REGULAR MEETING – PLANNING AND ZONING COMMISSION AGENDA

OCTOBER 22, 2025, 6:00 PM

- A. #2025-49 SP – Enrico R. Costantini, Esq. – 284 New Canaan Avenue – Request to modify Special Permit #12-16 to expand the area of the previously approved contractors yard and change the stormwater management - Continuation of public hearing, report & recommended action**

- B. #2025-56 SP/CAM – Alpha5MK 19 Day , LLC – 19 Day Street (District 2, Block 58, Lot 44) – Special permit for a proposed multifamily building with 32 units - Public hearing, report & recommended action
- C. #2025-59 R – RMS Real Estate Group, LLC – Zoning Regulation Text Amendment to Article 7 (Sign Standards) to create a “Cornice Sign” sign type and permit Cornice Signs within the CD-3C and CD-4 zones - Public hearing, report & recommended action

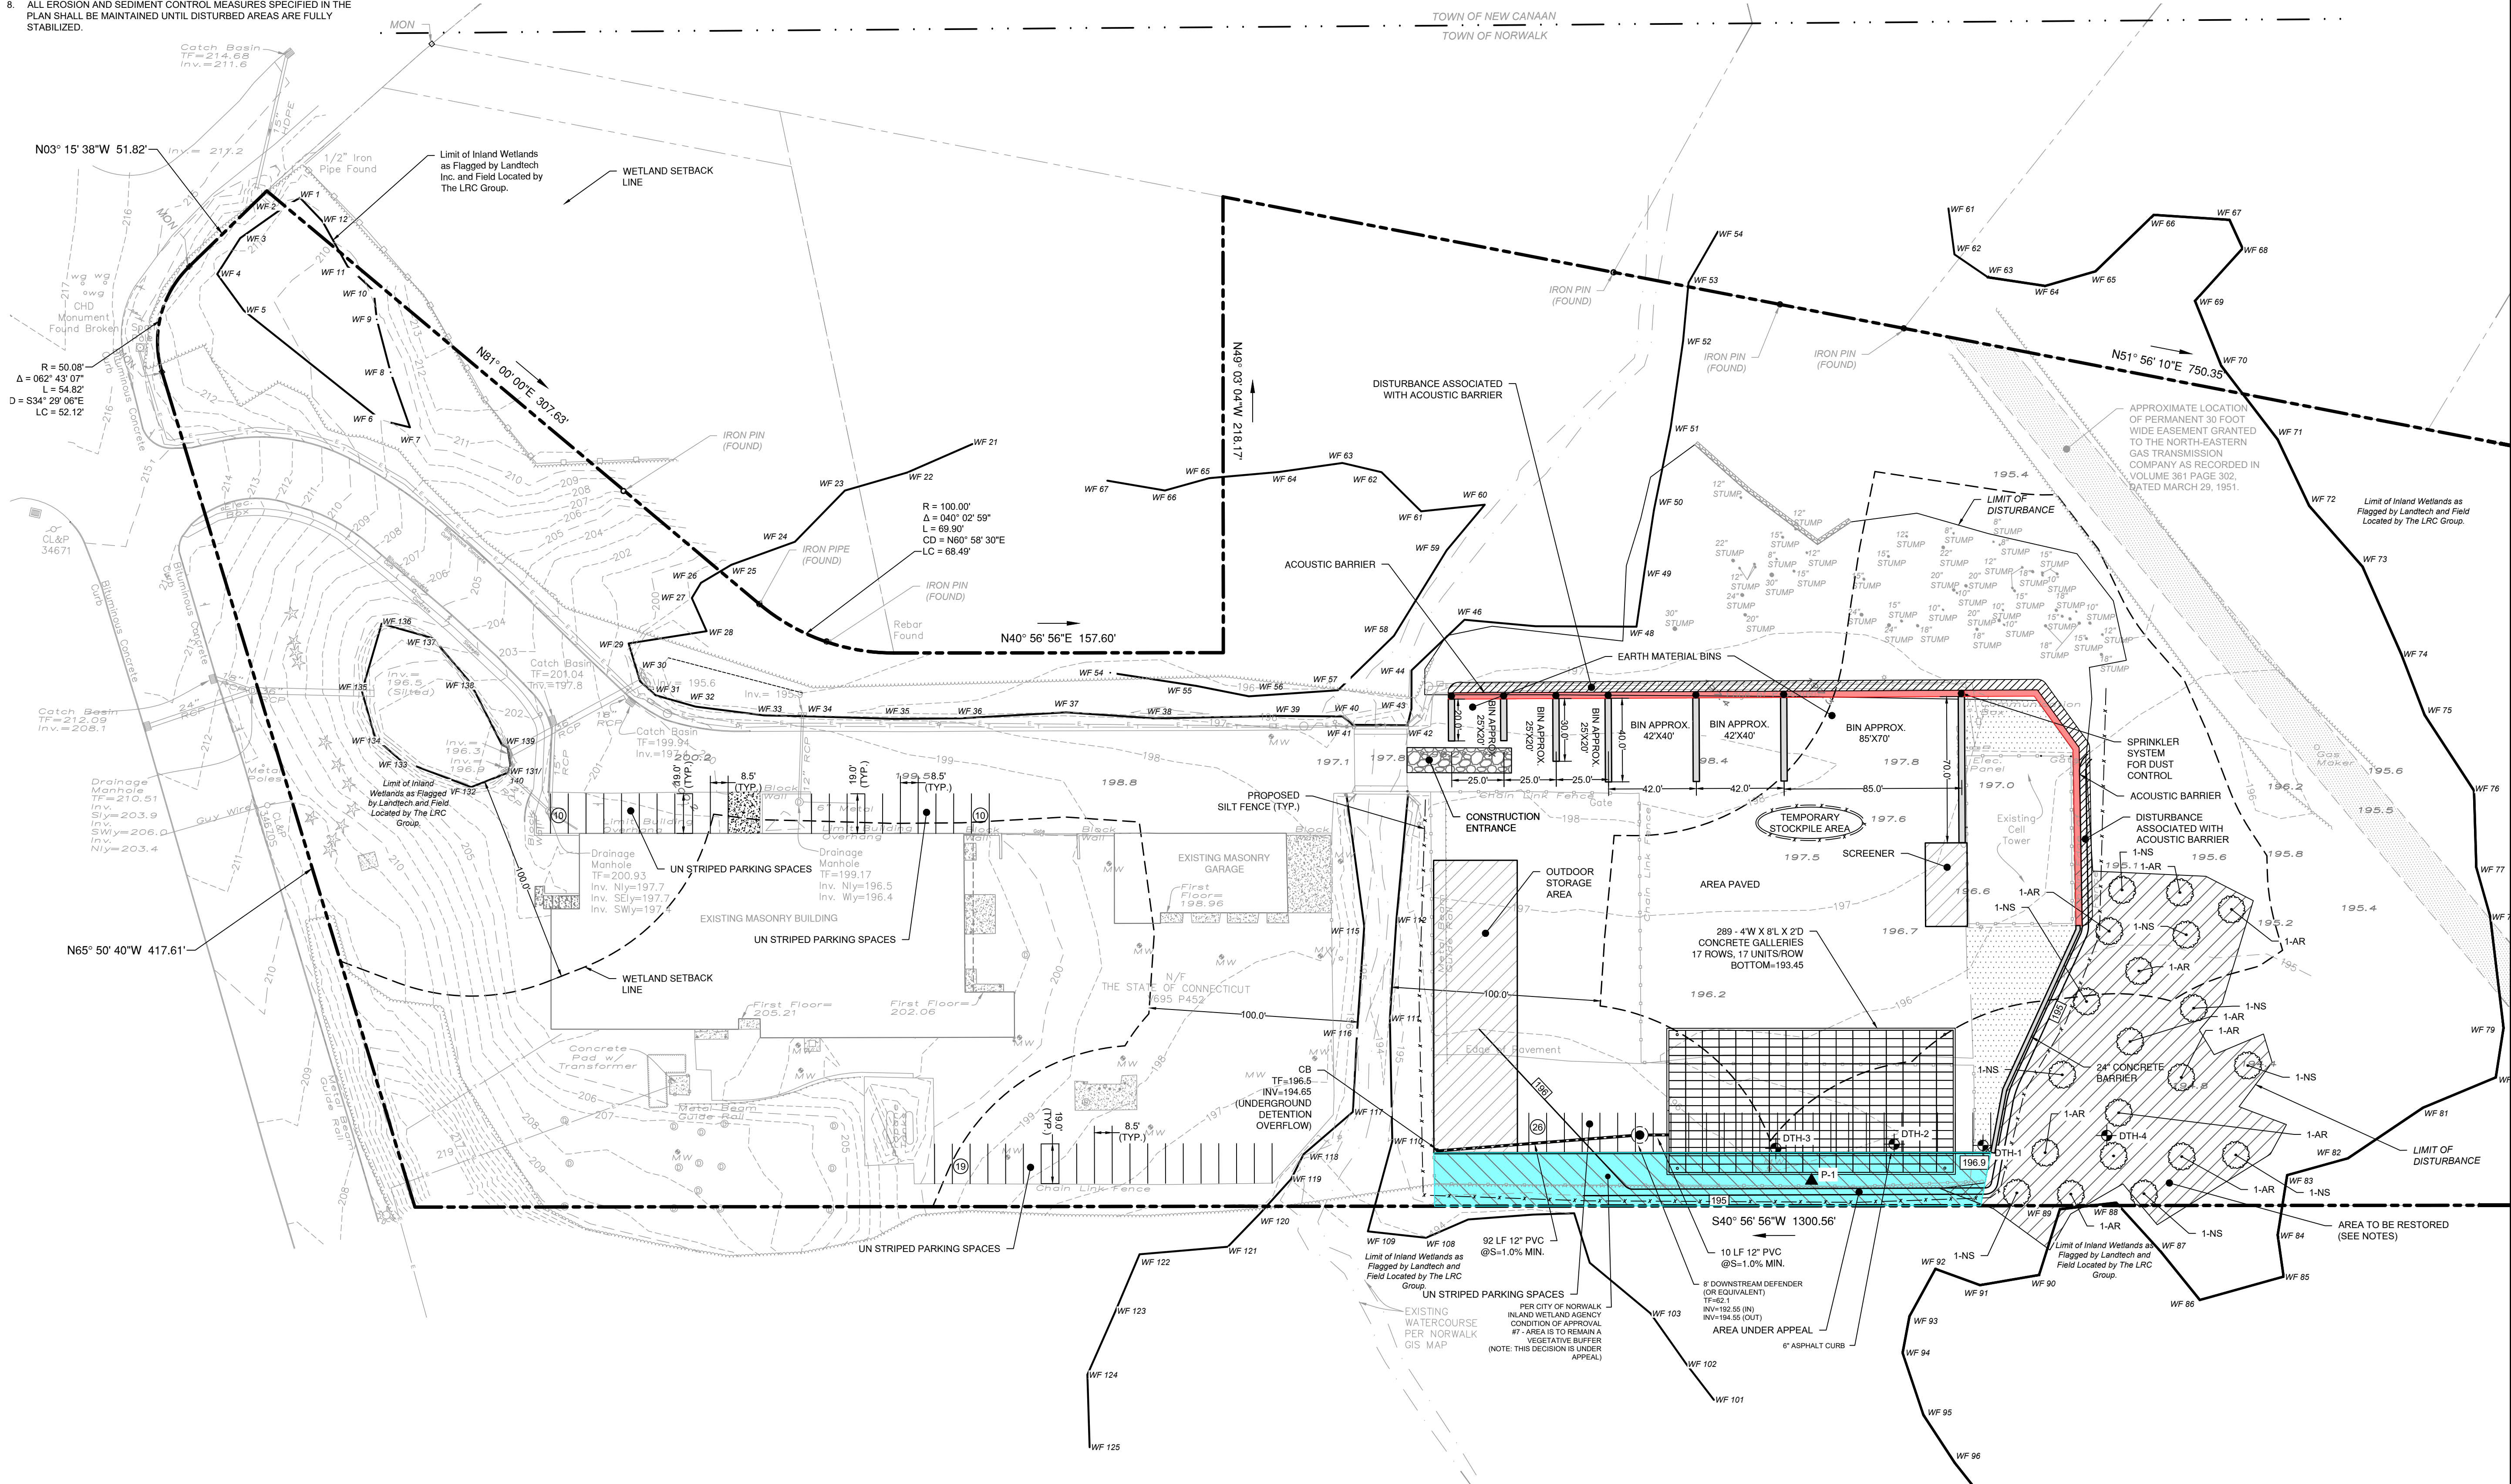
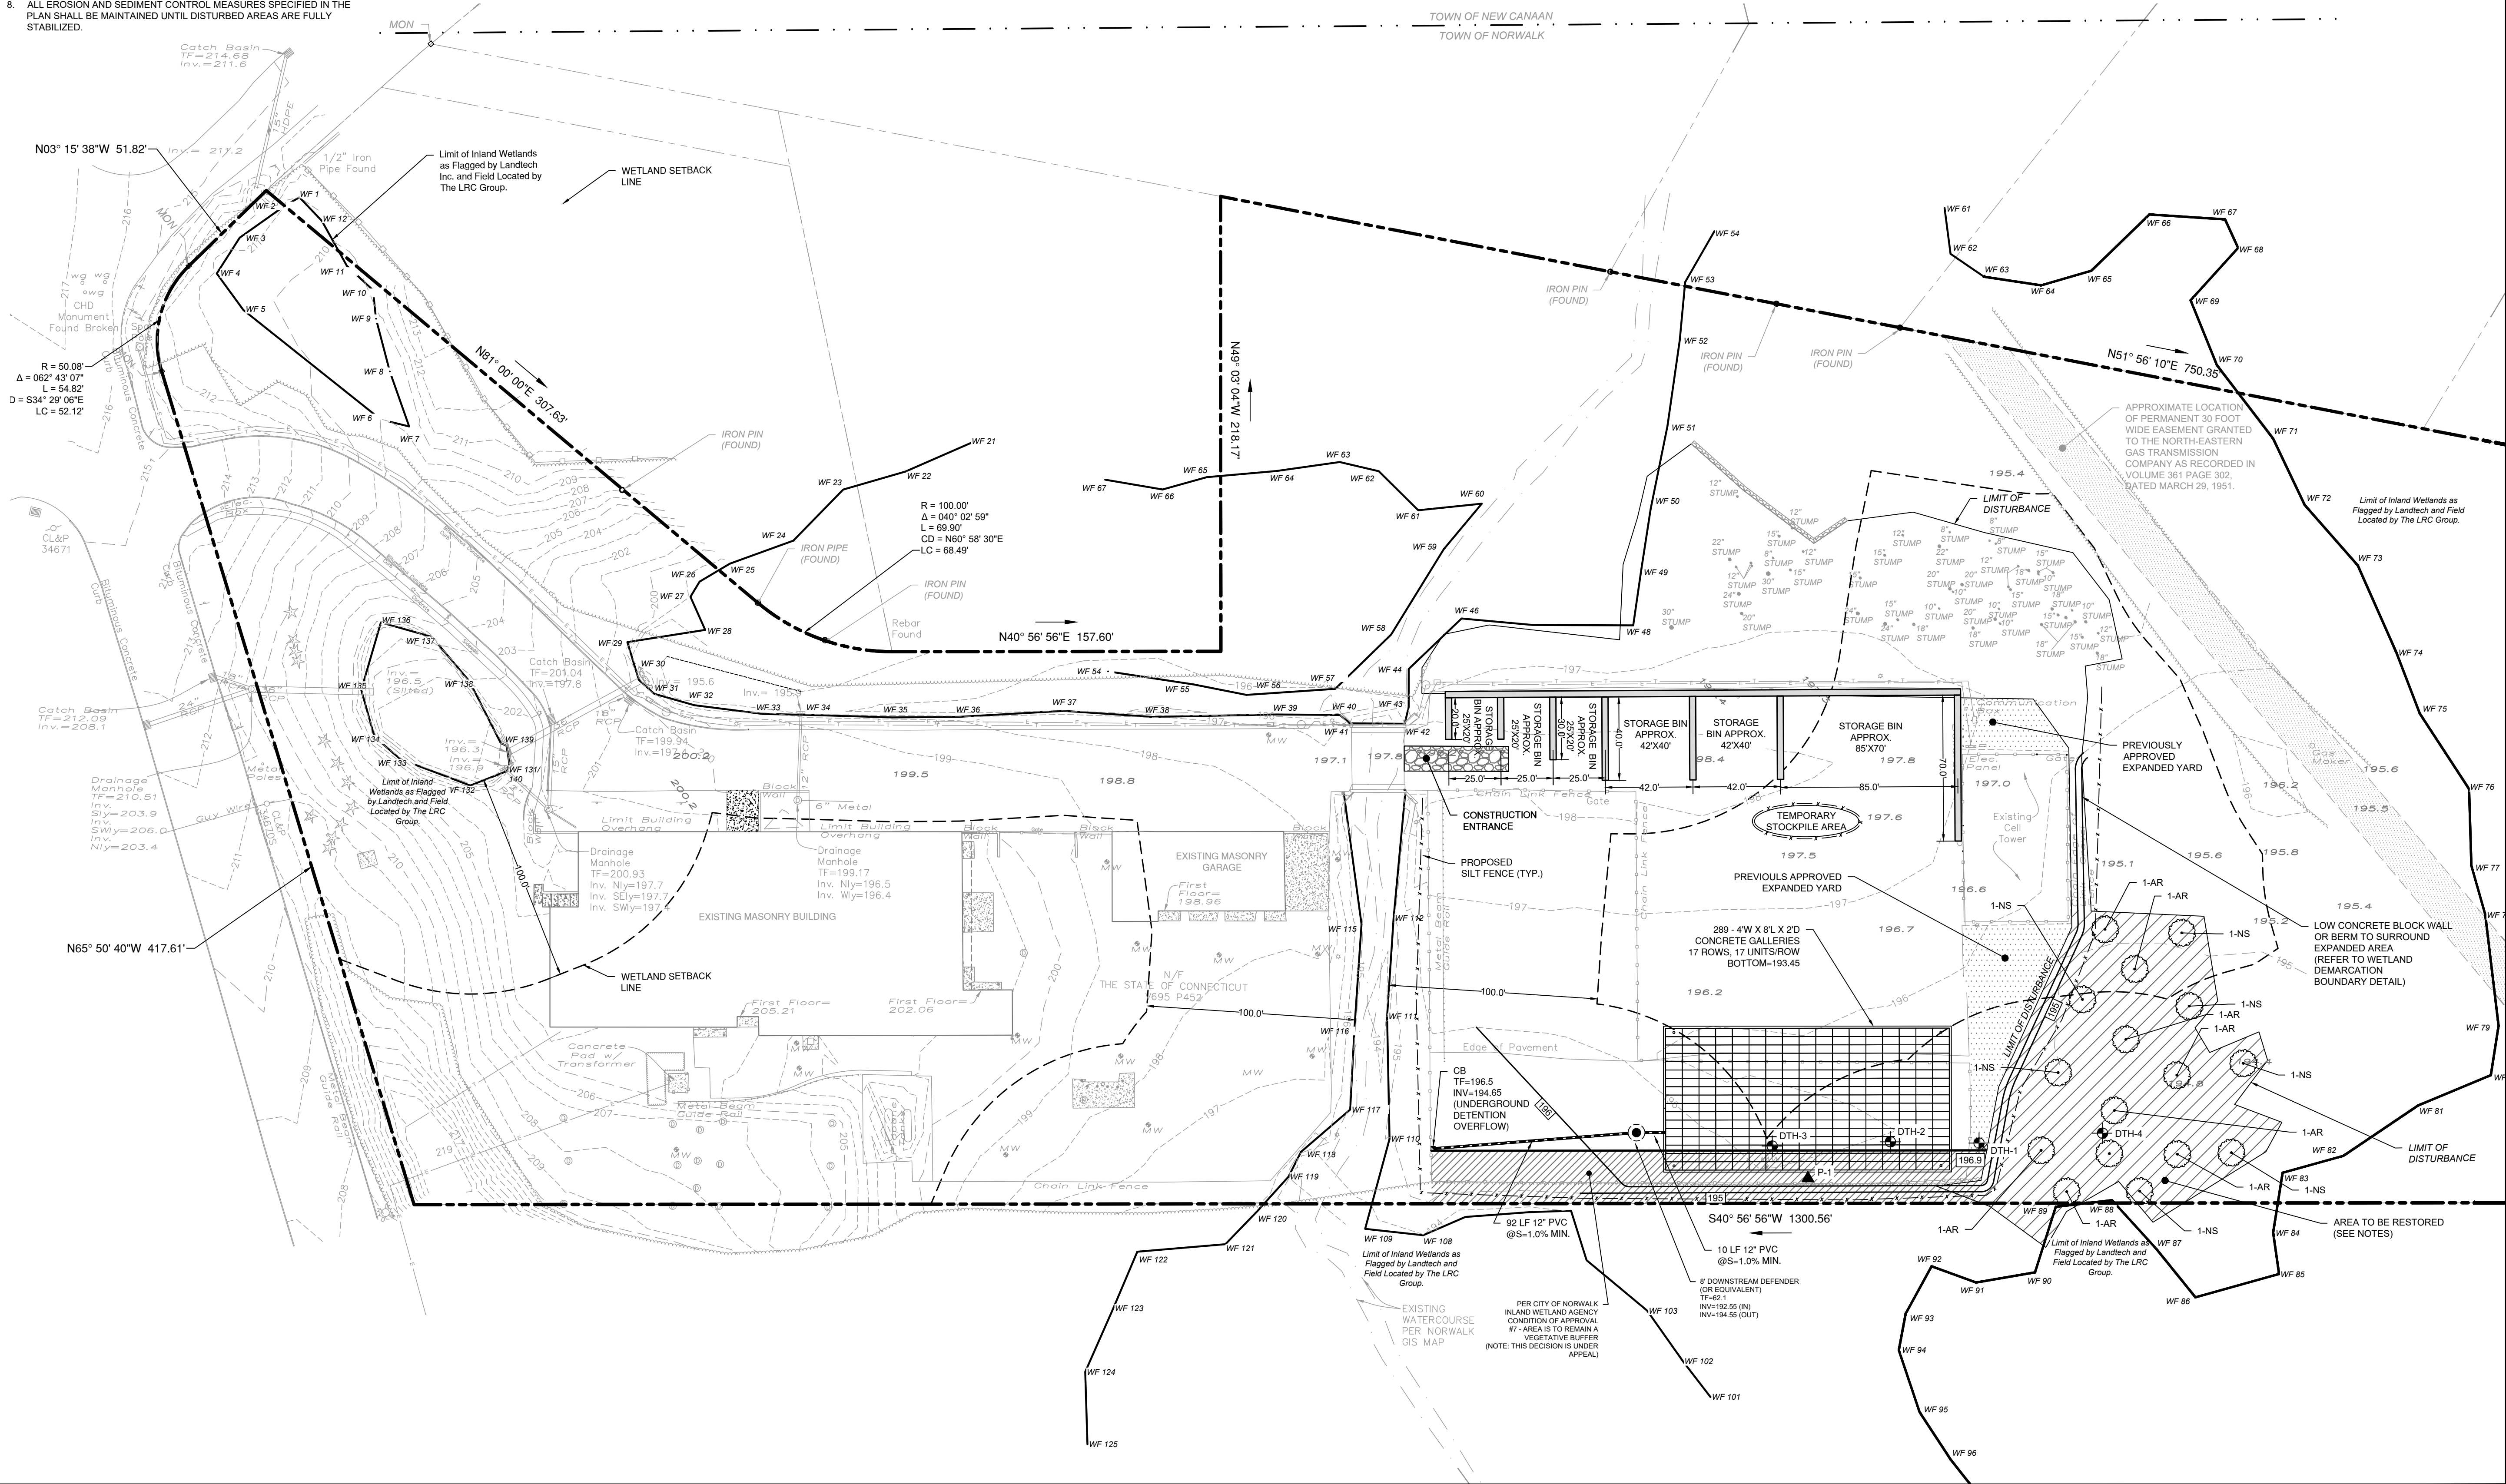
Staff Comment	Applicant Response	Reference
3. Revise plan per IWA permit (Conditions #3 & #7) and update revision date.	Site Development Plan updated (rev. 9/9/25) to incorporate IWA permit issued 5/13/25. Condition #3: 20+ native trees, invasive removal, restoration planting. Condition #7: curb/pavement of drainage areas, 25' vegetated buffer (maintained pending appeal).	Site Development Plan (C-1.0, C-2.0, C-3.0, rev. 9/9/25)

- Updated Site Development Plan (C-1.0, C-2.0, C-3.0 rev. 9/9/25)
- Site-Specific O&M Reports (Aug. 18, 2025)
